ORLANDO AUDI

SUMMARY

Minor Subdivision Plat

PROPOSED PLAT

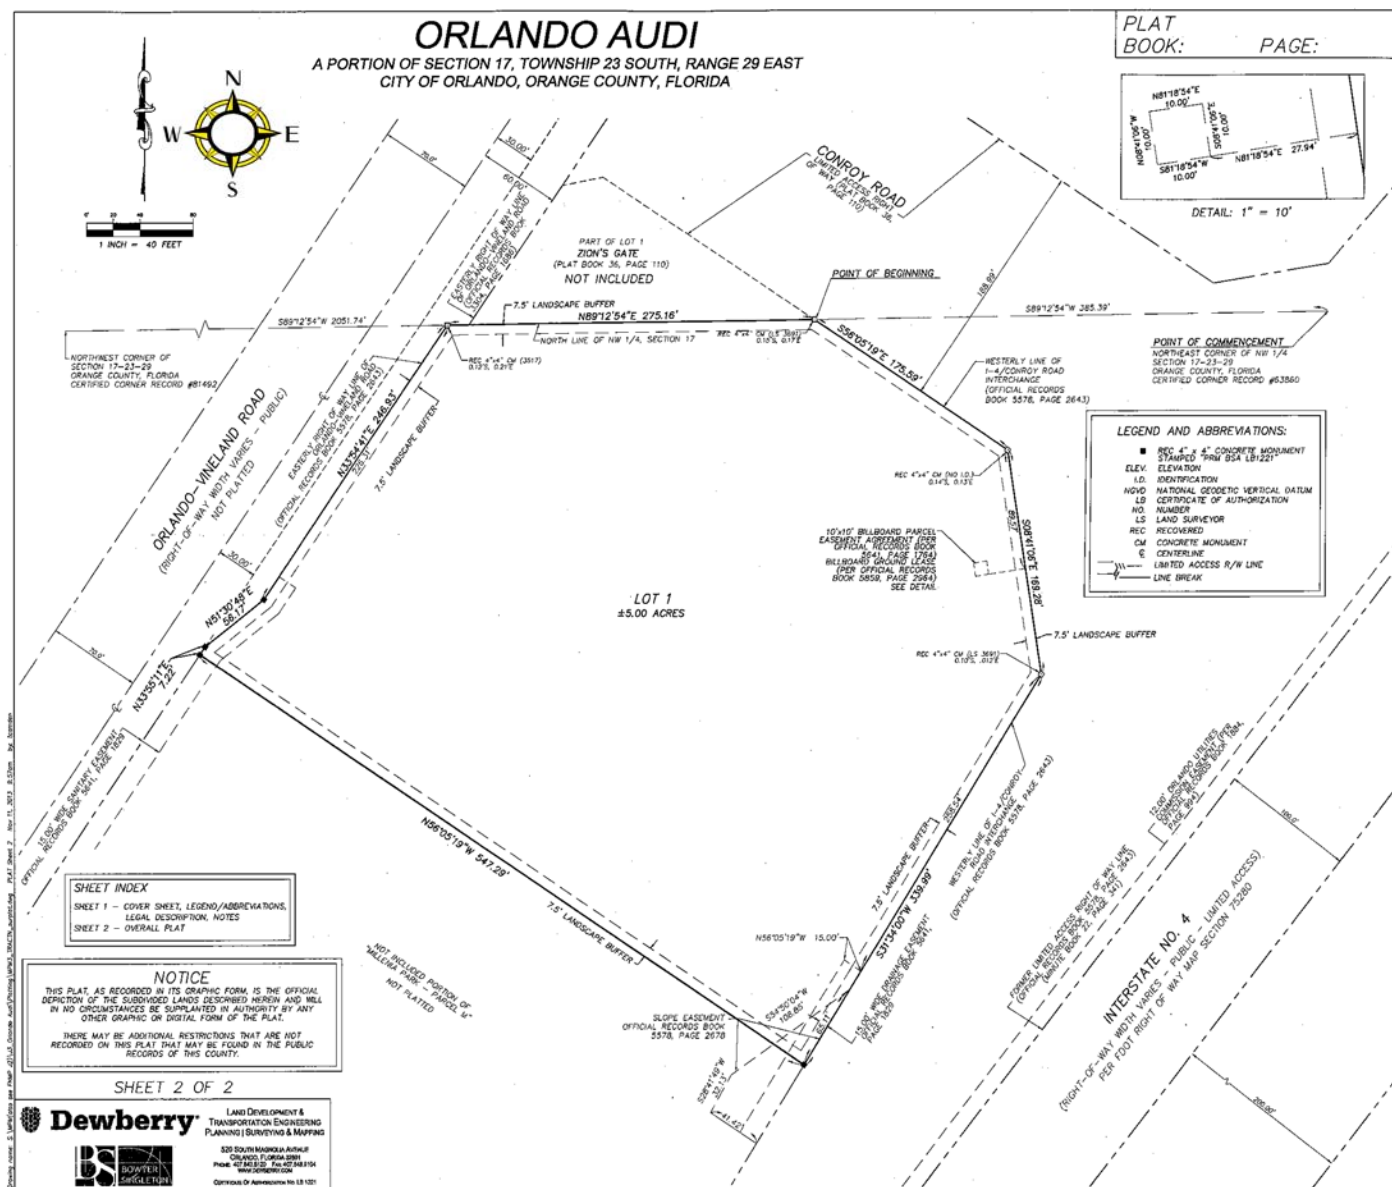
1. Plat Face Changes: In addition to the changes required on the plat, the following is a list of additional requirements:
 - a) Changes to the face of the plat (a copy has already been returned to the surveyor).
 - b) Recording Fees (Checks should be made payable Orange County Comptroller).
 - c) The plat must be reviewed by Orange County prior to recording. Begin this process by taking a copy of the executed plat to Sun Trust Bank Center, 200 S. Orange Ave., Orange County Property Appraiser's Office, 17th Floor, Room 1700, Attn: Rocco Campanale. The original completed Statement of Lien from Orange County is required by this office and must be received by this office prior to recording the plat.
2. Cross-Access Easement - A cross access easement is required for the driveway to the south (providing access to a signalized intersection at Vineland Rd.).

Transportation Planning - The owner/applicant shall dedicate a minimum of five (5) feet of City Services Easement for the length of the property along Orlando-Vineland Rd., in addition to the 7.5 feet landscape buffer, to meet LDC Section 61.152 requirements; the additional five (5) feet of City Services Easement shall be shown on the face of the plat (condition matches up with Trans. Plng. Condition #3 from MPL2013-00015 report).
